Ref. ID ADHOC-D-26-02099
"Onset-Anchored Selective Computation for Resource-Constrained Vehicular Edge Networks"
(submitted as "Trustworthy Selective Computation for Resource-Constrained Vehicular Edge Networks"; retitled in this revision, see R3.7)

Response to Reviewers*

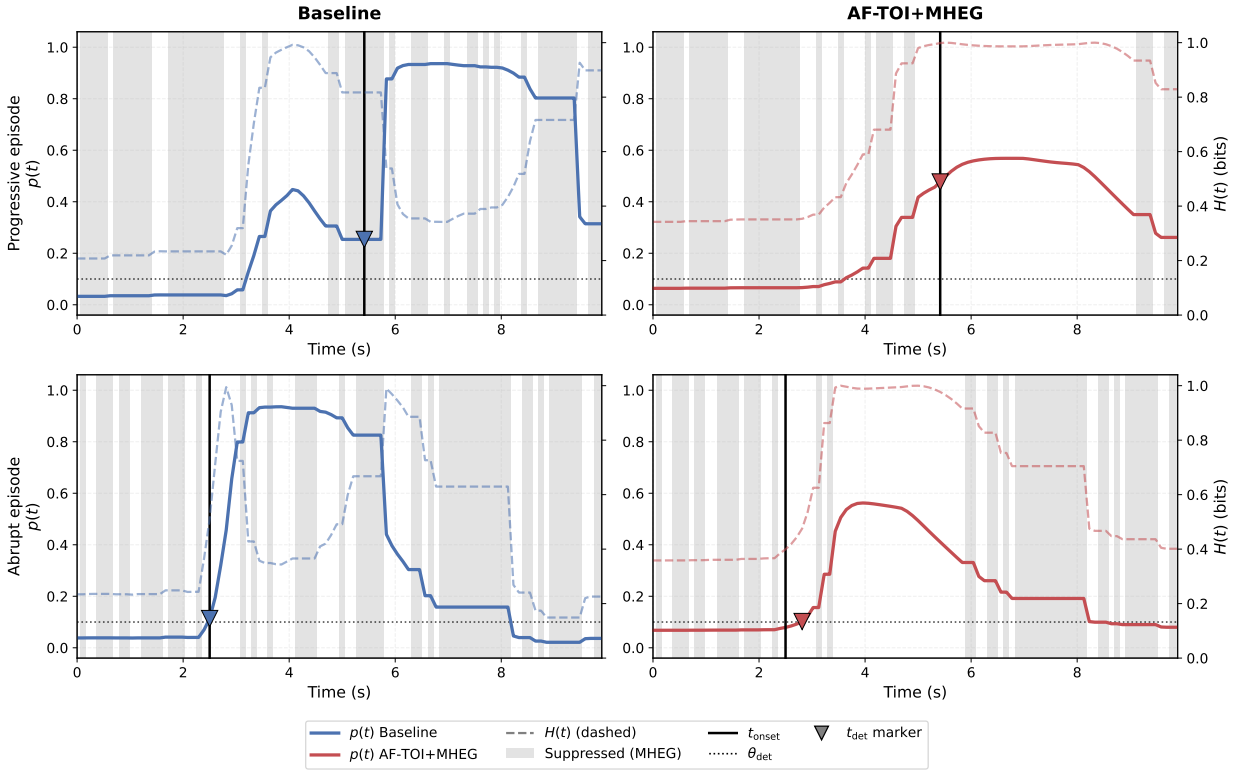
6. Comment: Frame-by-frame temporal evidence for seed 42 graph is not explained well.

Response: We agree with the reviewer. A frame-by-frame reading guide has been added to the paragraph following the first mention of Figure 5 in Section 4.2, identifying each visual element of the seed-42 examples. During revision verification we also found and corrected two problems in this figure, and we report them explicitly rather than silently: (a) the exemplar episodes of the submitted version were not selected by a stated criterion, and the abrupt exemplar was atypical (it belongs to a saturated minority of episodes whose entropy sits near the maximum throughout); the figure now uses, per regime, the episode with the *median* pre/post-onset entropy contrast among seed-42 critical episodes with central onset, and the caption states the criterion; (b) the replay that produced the suppression shading applied the entropy threshold in the wrong logarithm base (natural log instead of the base-2 entropy of Eq. 11), so the entropic branch of the gate never fired in that log; the log was regenerated with the correct base, and the entropy axes of Figures 4–6 are now uniformly

in bits, matching Eq. 11. The added text reads:

(The full frame-by-frame reading guide follows the first mention of Figure 5 in Section 4.2.) Its selection criterion reads: "The exemplars are selected by a pre-declared neutral criterion: within each regime, the episode whose pre/post-onset entropy contrast is the *median* among the critical episodes of seed 42 with a centrally located onset (progressive: episode 36, t_0=5.42 s; abrupt: episode 148, t_0=2.50 s)." The guide also states that detection markers of single exemplars do not arbitrate latency (aggregate latencies are settled by Table 8) and that a minority of abrupt critical episodes (12 of 48 in seed 42) runs near maximal entropy throughout. The regenerated figure is reproduced below.

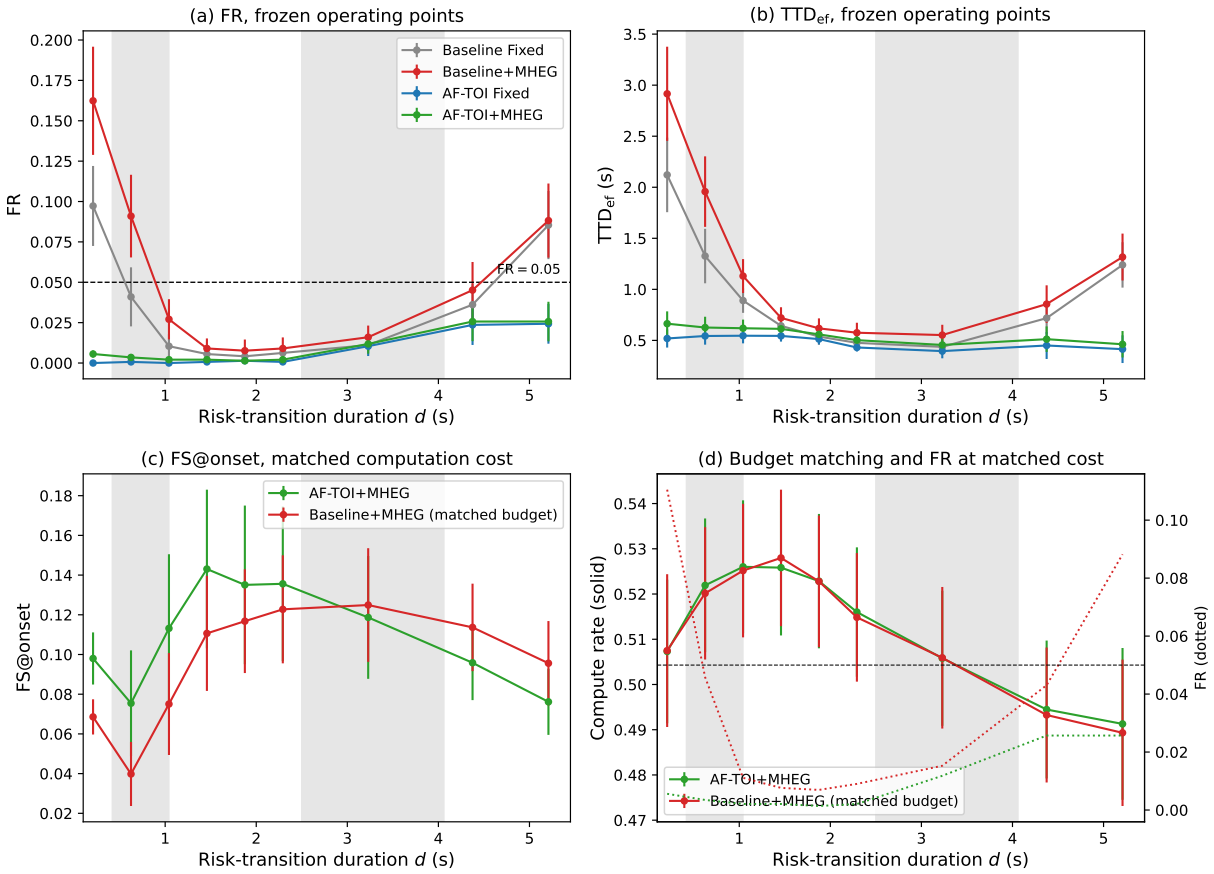
4. Comment: A central claim of the study is that temporal organization of uncertainty is important for safe selective computation, but the current experiments appear to be strongly tied to the risk-transition patterns defined by the experimental setup. The authors should investigate whether AF-TOI generalizes to unseen temporal risk trajectories, different onset durations, abrupt versus gradual transitions, intermediate-risk conditions, changes in the distribution of input features, or distribution shifts between training and testing conditions.

Response: We agree with the reviewer. To address the question of generalization across different transition durations, a new temporal-scale experiment has been added in Section 4.12, together with Figure 14 and Table 21. The experiment varies the risk-transition duration independently through a shape-preserving temporal warp while keeping t_0, the normalized transition shape, the episode context, the model weights, and the scheduler thresholds fixed. The limitations paragraph of Section 5 was also revised to distinguish this controlled temporal train–test shift from broader naturalistic distribution shift. The six aspects raised in the comment are addressed as follows.

(ii) *Different onset/transition durations* are evaluated by the new experiment of Section 4.12, across nine durations from 0.21 to 5.21 s, including interpolation and extrapolation outside the training support.

The new Section 4.12 (Figure 14, Table 21) reads:

"Figure 14a–b and Table 21 report the frozen operating points. AF-TOI maintains mean FR below 0.05 at every evaluated duration (maximum duration-wise mean 0.026), and $\mathrm{TTD}_{\mathrm{ef}}$ stays within approximately 0.40–0.66 s. The Baseline crosses mean FR = 0.05 at both extrapolation extremes (mean FR 0.097 at 0.21 s and 0.085 at 5.21 s for the fixed policy), and its $\mathrm{TTD}_{\mathrm{ef}}$ follows a U-shaped profile that reaches 2.12 s at the fast extreme. At the level of individual seed×duration cells, AF-TOI exceeds FR = 0.05 in 7 of 108 cells (all at $d \geq 3.23$ s, maximum 0.108), against 22 of 108 for the fixed Baseline (maximum 0.250) and 32 of 108 for Baseline+MHEG (maximum 0.333). Frame-level F1 remained seed-sensitive under the warp, a pattern consistent with checkpoint-level variability rather than with an effect of the warp itself. Accordingly, the result is restricted to aggregate coverage and effective delay and does not constitute a per-seed guarantee: AF-TOI shows aggregate temporal-scale robustness across the evaluated synthetic range of unseen risk-transition durations." (Section 4.12, second paragraph)

"Because the two frozen gates suppress different fractions of frames, we added a post-hoc matched-budget diagnostic: for each seed×duration cell, the entropy threshold of Baseline+MHEG was adjusted by bisection (...) until its computation rate (fraction of executed window updates; both arms share the recompute semantics) matched that of AF-TOI+MHEG on the same cell (all 108 cells matched within 1.9%, tolerance 2%; Figure 14d). (...) At matched computation cost, no systematic FS@onset advantage remains (...). Under Holm correction within each endpoint family, only the $\mathrm{TTD}_{\mathrm{ef}}$ difference at 0.21 s remains significant ($p = 0.031$), so these per-duration matched-cost contrasts should be read as exploratory. The matched-budget diagnostic supports a temporal-scale coverage-and-timeliness advantage, not a universal improvement in near-onset suppression placement." (Section 4.12, third paragraph)
